**Vehicle Out Of Fuel –  
Range Indicated On Message Center –  
Modify Transfer Pipe**

MODEL 2002 MY  
X-TYPE  
VIN C00001-C39700

ILLUSTRATION 1

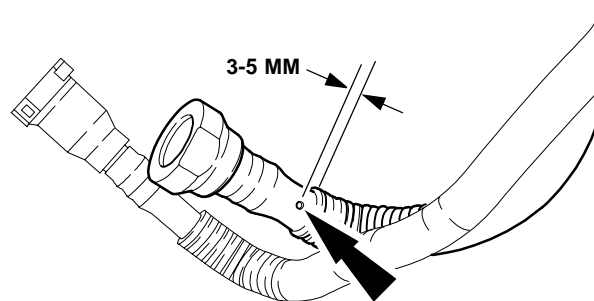
1. Remove the fuel transfer pump assembly (see Workshop Manual, JTIS CD ROM section: 310-01, SRO 19.45.06).
2. For access, reposition the return transfer pipe away from the fuel tank opening (return transfer pipe has a yellow release latch).
3. Using a 2 mm drill bit, by hand, drill a hole 3 mm to 5 mm from the shoulder (convoluted pipe side) in the return transfer pipe and remove any swarf (Illustration 1).

**DRILL HOLE 3-5 MM FROM SHOULDER**
